NORTHERN BEACHES LOCAL PLANNING PANEL MEETING

WEDNESDAY 6 NOVEMBER 2019

1.0	APOLOGIES & DECLARATIONS OF INTEREST	
2.0	MINUTES OF PREVIOUS MEETING	
2.1	Minutes of Northern Beaches Local Planning Panel held 16 October 2019	
3.0	DEVELOPMENT APPLICATIONS	5

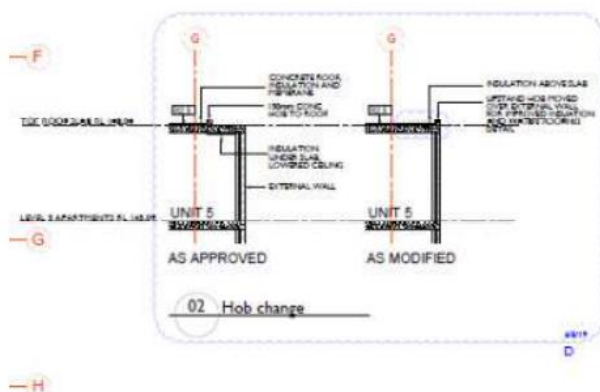
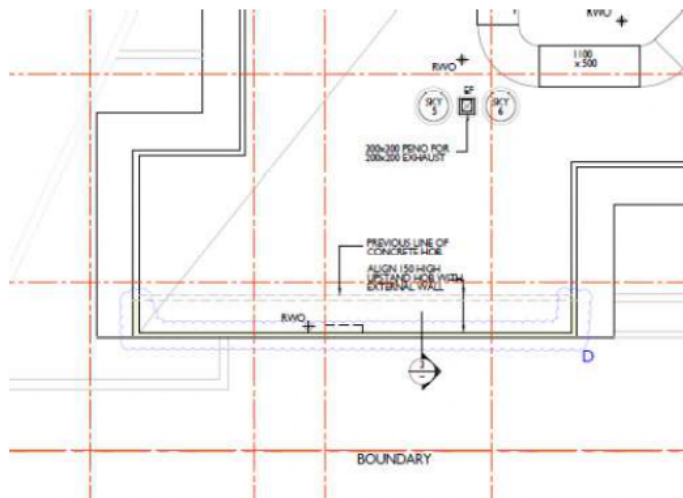
- The plans show a number of inaccuracies from the elevation view of the location of the roof mounted plant including the car park discharge, retail condensers and lift overrun. For example, the roof plan states, 'car park exhaust discharge - top of duct 1100 off slab'. The car park exhaust discharge should be visible on the north-east elevation as it is located on the south-eastern side of the two retail condensers. The car park exhaust duct should also be visible on the south-west elevation behind the lift overrun as the top of the duct (RL149.14) is higher than the top of the lift overrun (RL148.94). The notification of the proposal is not valid as the plans do not accurately represent the modifications sought.

- The mechanical plant will be visible from the public domain and have a detrimental impact upon the visual quality of the building and attribute to additional building height above that already approved. More detailed sight lines should be provided to show the impact of the roof top plant and the single submitted sight line is not sufficient to show there will not be a visual impact. If the sight line diagrams demonstrate that the proposed additions to the roof will in fact be visible Council should request that the additions be screened from view by an appropriately designed structure (such as a louvered/perforated screen) made from a durable material and integrated into the design of the development. The applicant should also be requested to demonstrate that they are unable to reduce the height of the additions. The proposed retail condensers with a height of 1500mm appear excessive as smaller condensers could be selected.

It is agreed that the application as initially lodged did not provide a satisfactory outcome with regard to visual impact, with all mechanical plant exposed with no screening around the mechanical plant. An updated set of plans have since been provided which included 1.5m height aluminum louver screening around the mechanical plant to assist with mitigating visual impacts. The solution is considered a satisfactory response to screen the the mechanical plant. Some ductwork remains exposed however is only at a low level which will not cause a visual impact from the street level or adjoining properties. A number of sight line diagrams were submitted with the application, however the two diagrams demonstrating the ground level view from Grandview Drive were provided upon an internal section plan. For privacy reasons, the section plans are not included within the notification plans as they contain internal residential floor layouts. Therefore, the applicant has provided a complete set of view sight lines from both street frontages showing the roof top plant is obscured from street level. The provided sight lines and louvered screening demonstrate an acceptable visual outcome with the 1.5m height mechanical plant selected for the proposal.

Figure 1 - Site line diagram demonstrating that the breaching roof top elements will not be discernible as viewed from the street or surrounding residential properties.

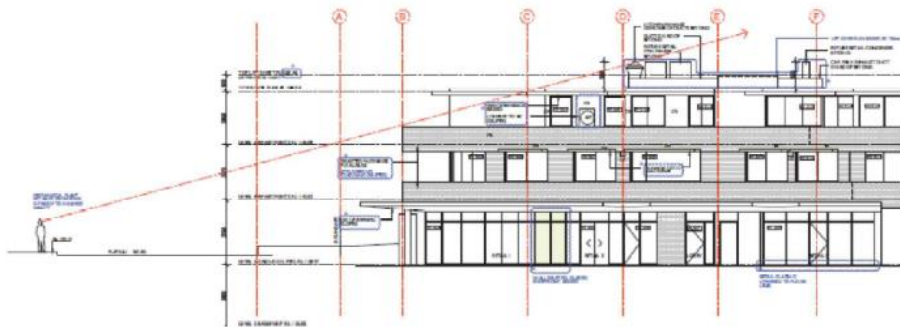
Comment: *The proposed roof top mechanical plant and exhaust structures are required to satisfy the SCA in terms of ventilation of the basement and to facilitate the use of the retail tenancy as a food and drinks premises. The breaching elements have been located centrally on the roof of the building to ensure that they are not discernible as viewed from the street or surrounding residential properties as depicted in Figure 1 below.*

The breaching elements will not impact on the design quality of the approved building or its streetscape and residential amenity outcomes and to that extent the building, by virtue of its height and scale, will remain consistent with the desired character of the locality being an outcome accepted in the approval of the original scheme. The proposal is consistent with this objective.

Figure 1 - Extent of building envelope non-compliance (highlighted in green)

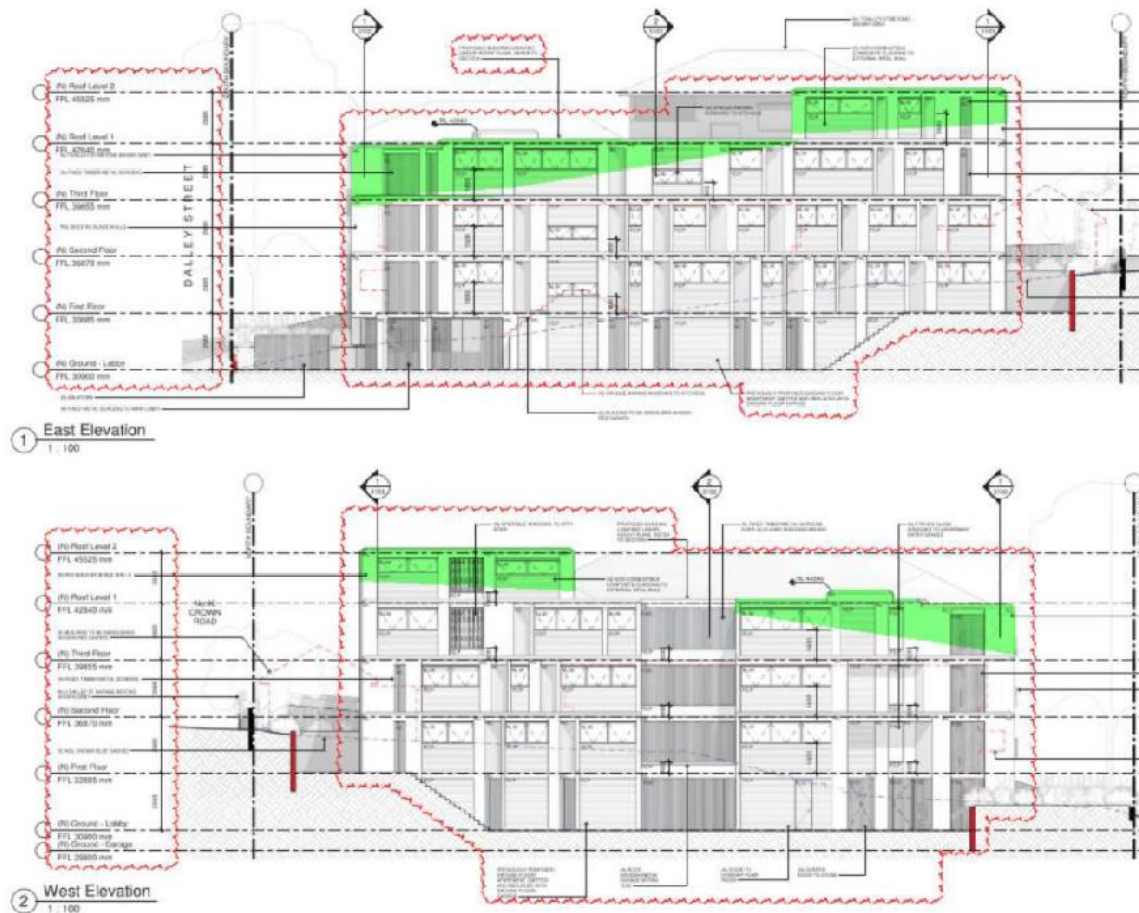
The proposed development protrudes beyond the 5m building envelope on both the eastern and western sides of the proposed development, as highlighted in green in **Figure 1**, below. It is relevant to note that the areas of non-compliance generally align with those parts of the building that also exceed the 3 storey height limit prescribed by clause B2 (Number of Storeys) of WDCP 2011.

The proposed breach of the building envelope is not supported, as the proposed development cannot be said to achieve consistency with the objectives of the development control, as follows:

Figure 2 - Location of individual units at 7 Dalley Street.

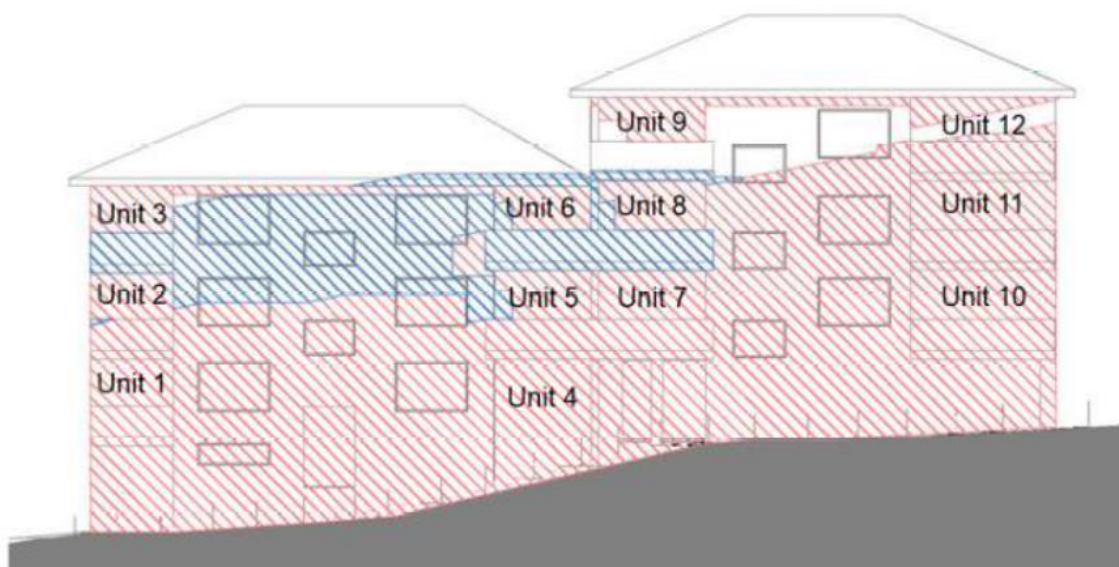
This development control also prescribes that at least 50% of the required area of private open space of adjoining dwellings is to receive a minimum of 3 hours of direct sunlight between 9am and 3pm in midwinter. In this respect, the proposed development attributes to additional overshadowing of areas of primary private open space of Apartments 2, 5, 6, 7 & 8 at 7 Dalley Street to the west and Apartments 8 and 12 at 3 Dalley Street to the east, the specific location of which are highlighted in **Figure 2** and **Figure 3**, below.
